Office Action Summary

10/662,751

GOSS ET AL.

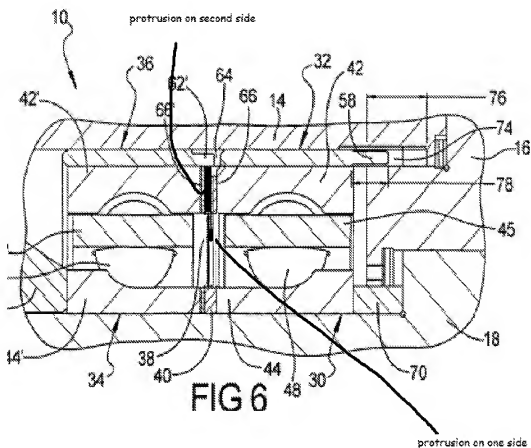
Upon further review of figure 6, the examiner believes to have located the protrusion of opposite sides of the spring.

The spring, in the examiner's view, is illustrated above in black. If this is the case, then the original drawing should be filed, with proper cross hatching. Amended figure 6 as filed July 9, 2008 will not be entered as it deviates significantly from what was originally illustrated. Figure 2 filed on November 27, 2007 should also be filed in response to this Office Action. No other drawings filed November 27, 2007 will be entered.

Corrected drawing sheets in compliance with 37 CFR 1.121(d) are required in reply to the Office action to avoid abandonment of the application. Any amended replacement drawing sheet should include all of the figures appearing on the immediate prior version of the sheet, even if only one figure is being amended. The figure or figure number of an amended drawing should not be labeled as "amended." If a drawing figure is to be canceled, the appropriate figure must be removed from the replacement sheet, and where necessary, the remaining figures must be renumbered and appropriate changes made to the brief description of the several views of the drawings for consistency. Additional replacement sheets may be necessary to show the renumbering of the remaining figures. Each drawing sheet submitted after the filing date of an application must be labeled in the top margin as either "Replacement Sheet" or "New Sheet" pursuant to 37 CFR 1.121(d). If the changes are not accepted by the examiner, the applicant will be notified and informed of any required corrective action in the next Office action. The objection to the drawings will not be held in abeyance.
